APPLICATION FOR SUBMITTAL OF POST-APPROVAL DOCUMENT

This addendum incorporates additional Wi-Fi and conduits to address the infrastructure for the RGB lighting system.

Pre-Bid ADDENDUM 2
(DSA ADDUNDUM 1)

Murrieta Valley High School

ENLARGED SITE PLAN

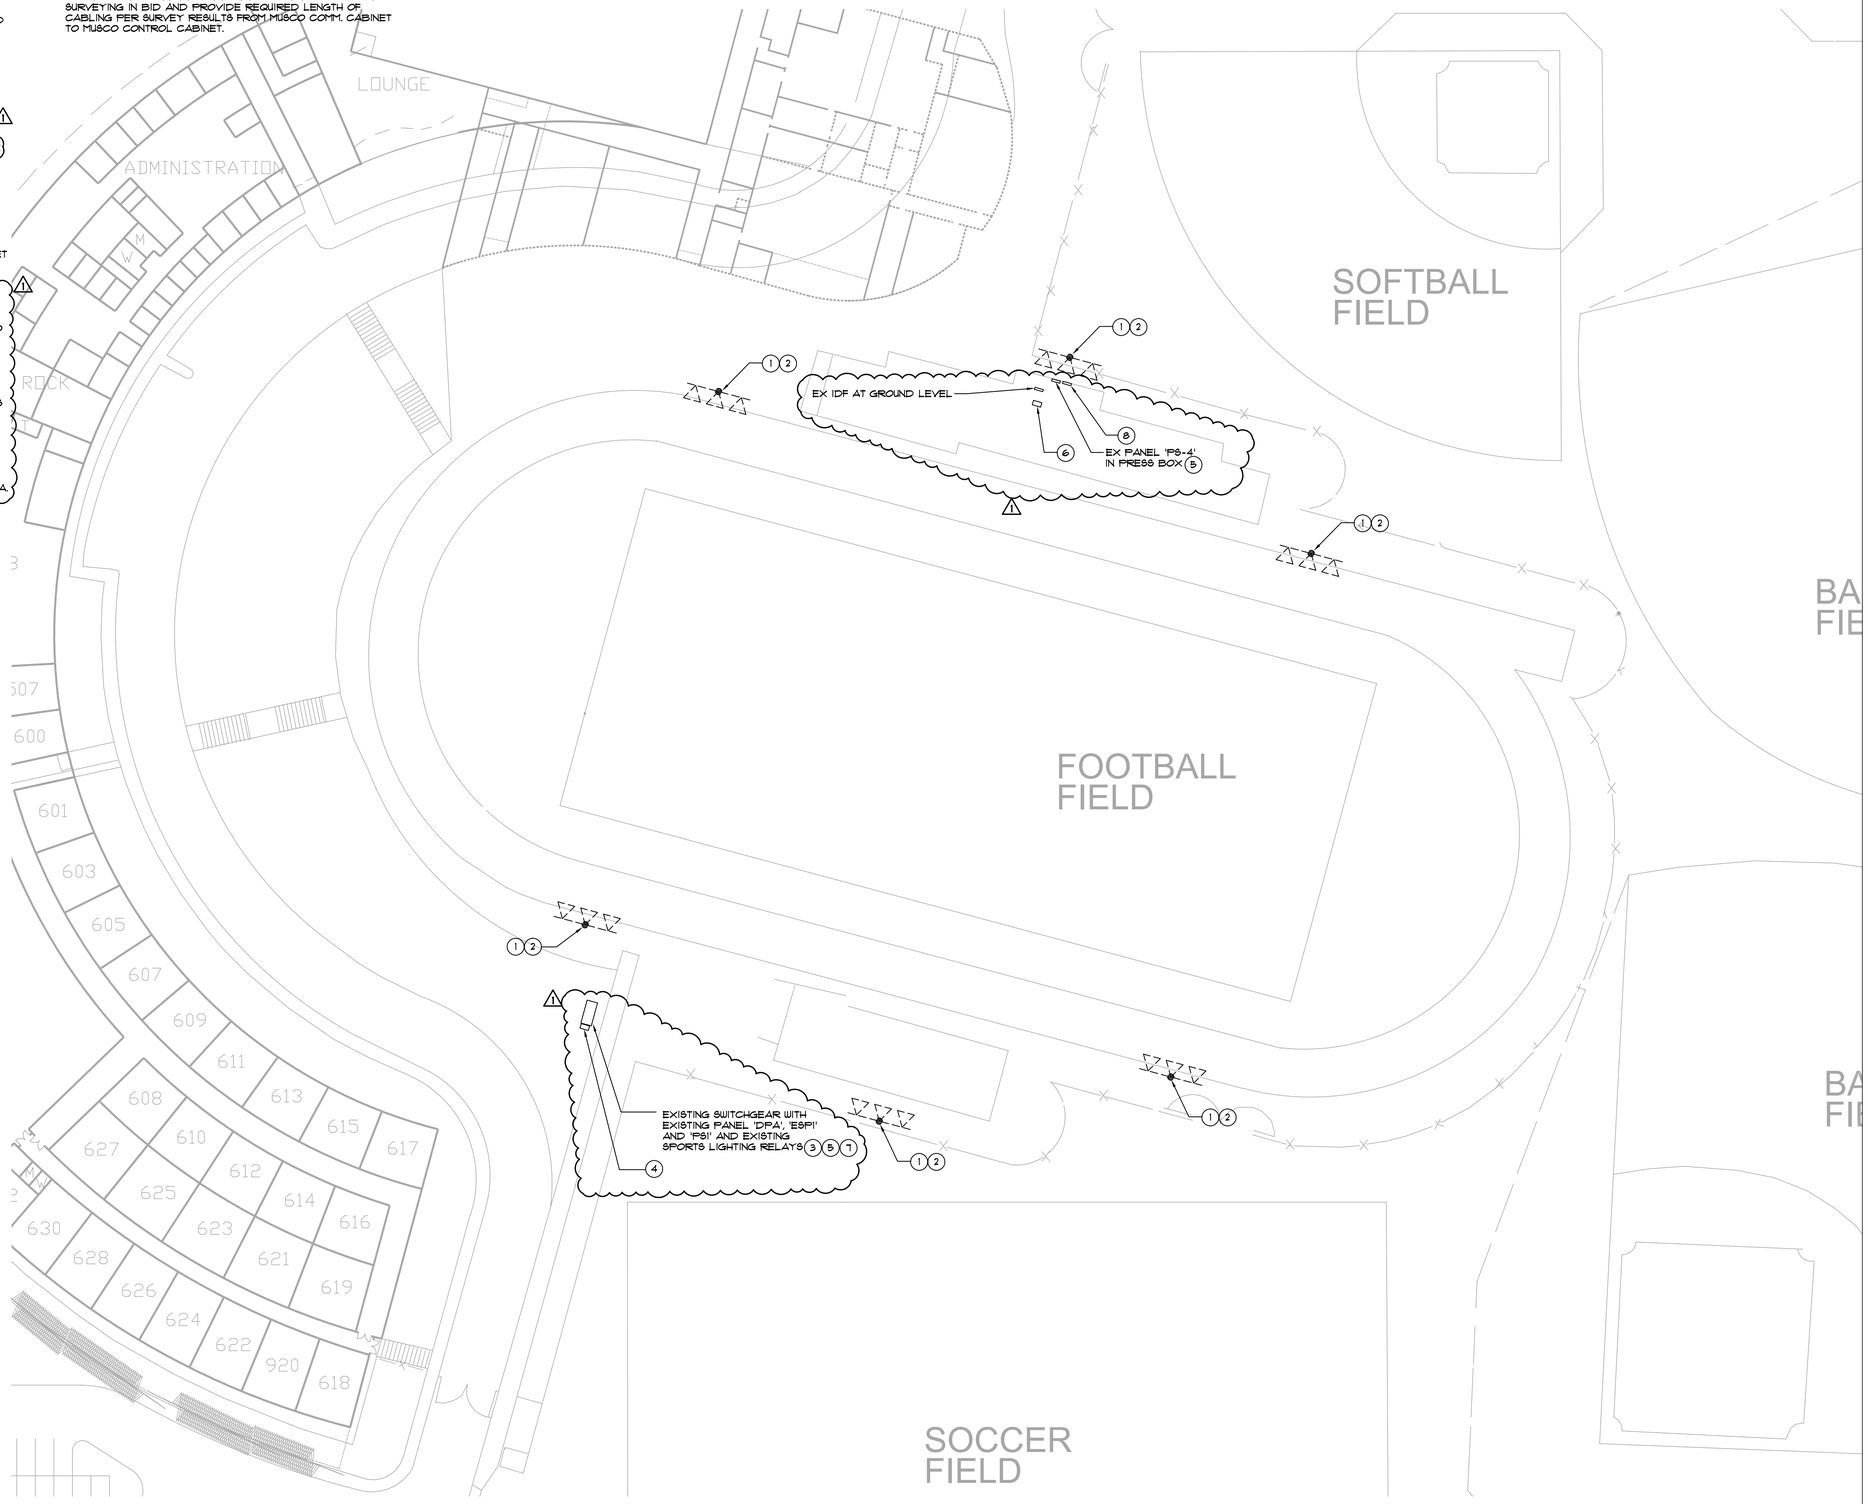
A. Drawing E1.2 – ENLARGED SITE PLAN: Revised currently issued drawing per AD-E1.2

1. EXISTING SPORTS LIGHTING POLE TO REMAIN. REMOVE EXISTING 'MUSCO' LIGHTS, CROSSARMS, CAPS, BRACKETS AND ALL OTHER EXISTING LIGHT FIXTURES SUPPORTS. REPLACE WITH NEW MUSCO LED LIGHTS, MUSCO FACTORY PROVIDED CROSSARMS, CAPS, BRACKETS AND ALL OTHER NEW LED LIGHT FIXTURE SUPPORTS . PROVIDE ALL REQUIRED MUSCO FACTORY WIRING EXTENSIONS, WIRING HARNESS, BRACKETS AND ALL NECESSARY PARTS TO MAKE A COMPLETE MUSCO SPORTS LIGHTING SYSTEM. EXTEND EXISTING NORMAL AND EMERGENCY LIGHTING CIRCUITS TO NEW LED LIGHT FIXTURES AS REQUIRED. COORDINATE ADDITIONAL REQUIREMENTS AND FIXTURE AIMING WITH MUSCO. PROVIDE BIRD SPIKES ON TOP OF MUSCO POLES, CROSS ARMS AND ALL NEW MUSCO LED LIGHT FIXTURES.

2. DISCONNECT AND REMOVE EXISTING BALLAST ENCLOSURE AND REPLACE WITH NEW COMPLETE AND FULLY FUNCTIONAL LED DRIVER ENCLOSURES AS REQUIRED.
3. ALL EXISTING CONDUCTORS TO REMAIN. EXTEND TO NEW MUSCO CONTROL CABINET AS REQUIRED. REMOVE EXISTING MUSCO CONTROL SWITCH. PROVIDE 120V POWER CONNECTIONS FROM EXISTING SPARE BREAKERS IN PANEL 'PS1', AND EXTEND TO MUSCO CONTROL CABINET, ALIC, AND COMM. CABINET. PROVIDE 3/4"C. 2 #12, 1 #12 GND. FROM EACH BREAKER TO ASSOCIATED CABINET.

4. NEMA 3R MUSCO CONTROL CABINET, NEMA 3R REMOTE RELAY CABINET AND NEMA 3R MUSCO COMM. CABINET. MOUNT TO SIDE OF EXISTING SWITCHBOARD.
5. PROVIDE (1) WP/GFI DUPLEX RECEPTACLE IN SECTION CONTAINING BREAKERS FOR SPORTS LIGHTING ON SIDE PANEL BEYOND DEADFRONT COVER. PROVIDE CUSTOM MADE BRACKET FOR MUSCO CONTROL TOUCH SCREEN. COORDINATE EXACT BRACKET WITH MUSCO.

6. NEMA 3R REMOTE RELAY. MOUNT TO EXTERIOR OF PRESS BOX BUILDING UNDER BLEACHERS OUTSIDE OF ELECTRIC ROOM. PROVIDE (1) 20A/1P BREAKER IN PANEL 'PS-4' AND 3/4"C. 2#12, #12GND FROM BREAKER TO CABINET. PROVIDE 1"C. FROM MUSCO COMMUNICATION CABINET TO CABINET AND 1"C. FROM COMMUNICATIONS CABINET TO THE CEILING OF THE PRESS BOX FOR ANTENNA.

7. MOUNT ALIC CABINET INSIDE SWITCHGEAR ABOVE THE PANEL 'DPA' SECTION. PROVIDE NIPPLE THROUGH TO ACCESS THE SECTION WITH PANEL ESPI. PROVIDE 120V POWER CONNECTIONS FROM PANELS 'PS1' AND 'ESPI'. PROVIDE 3/4"C. 2 #12, 1 #12 GND. FROM EACH BREAKER TO ALIC CABINET.

8. NEMA 1 COMMUNICATION CABINET. MOUNT IN MAIN ANNOUNCING AREA IN PRESS BOX. PROVIDE (1) 20A/1P BREAKER IN PANEL 'PS-4' AND 3/4"C. 2#12, #12GND FROM BREAKER TO CABINET. PROVIDE 1"C. FROM IDF TO CABINET WITH CAT 6 CABLE ANTENNA.

SPORTS LIGHTING ONE LINE DIAGRAM

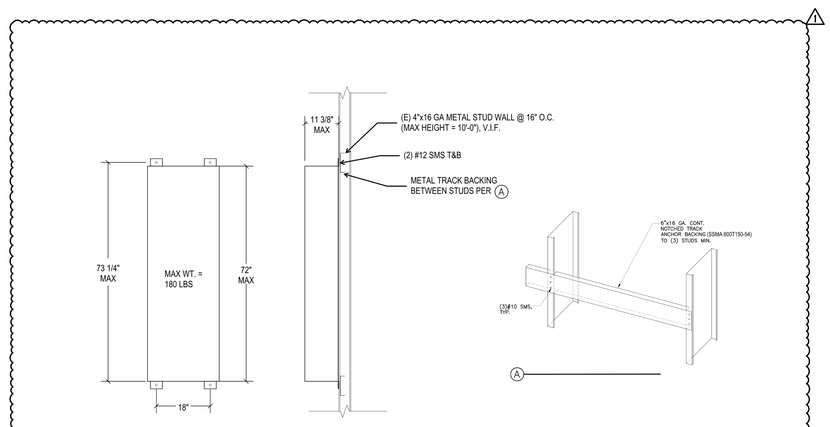
B. Drawing E7.1 – SPORT LIGHTING ONE LINE DIAGRAM: Revised currently issued drawing per AD-E7.1

1. PROVIDE FIELD INSTALLED NEUTRAL KIT IN THE CABINET AND CONNECT IN AND OUT NEUTRAL CONDUCTORS.
2. DISCONNECT AND REMOVE EXISTING 40A/3P BREAKER AND REPLACE WITH A NEW 30A/3P BREAKER. RECONNECT EXISTING CIRCUIT TO NEW BREAKER AS REQUIRED.

3. EXISTING INCOMING LIGHTING CIRCUIT CONDUIT AND CONDUCTORS TO REMAIN. EXTEND TO DESIGNATED LIGHTING CONTACTOR DOWNSTREAM SHOWN ON ONE LINE DIAGRAM AS REQUIRED.

4. RECONNECT INCOMING AND OUTGOING LIGHTING CIRCUITS AND EMERGENCY LIGHTING CIRCUITS TO ALL NEW CONTACTORS IN NEW SPORTS LIGHTING ENCLOSURE AS REQUIRED.

5. EXTEND AND RECONNECT EXISTING OUTGOING LIGHTING CIRCUITS TO DESIGNATED CONTACTORS UPSTREAM IN SPORTS LIGHTING CONTROL CABINETS AND POLE NEW DRIVER ENCLOSURES AND LED LIGHTING FIXTURE HEADS DOWNSTREAM SHOWN ON ONE LINE DIAGRAM AS REQUIRED.

6. EXISTING CONTROL CABINET TO BE REPLACED WITH NEW CONTROL CABINET. RECONNECT TO EXISTING 120V CONTROL CIRCUIT.
7. PROVIDE WIRING PER MANUFACTURER'S REQUIREMENTS.

8. REPLACE EXISTING 30A/3P CIRCUIT BREAKER WITH 40A/3P
9. PROVIDE NEW ALIC CABINET WITH NIPPLES AS REQUIRED TO PROVIDE 120V POWER CIRCUIT FROM PANEL 'PSI' AND EMERGENCY POWER FROM PANEL 'ESPI'. PROVIDE 2#12,#2GND FROM EACH PANEL TO ALIC.

10. DEMOLISH EXISTING CONDUCTORS FROM PANEL 'ESPI' TO POLE AND REPLACE WITH NEW CONDUCTORS.
11. PROVIDE REMOTE RELAY CABINET AND 1"C. FROM CABINET TO ANTENNA LOCATION. VERIFY EXACT LOCATION WITH MUSCO AS REQUIRED. ANTENNAS MUST BE IN DIRECT LINE OF SIGHT OF EACH OTHER.

12. REPLACE EXISTING SPARE BREAKERS IN PANELBOARD WITH NEW BREAKER IN SPACES INDICATED
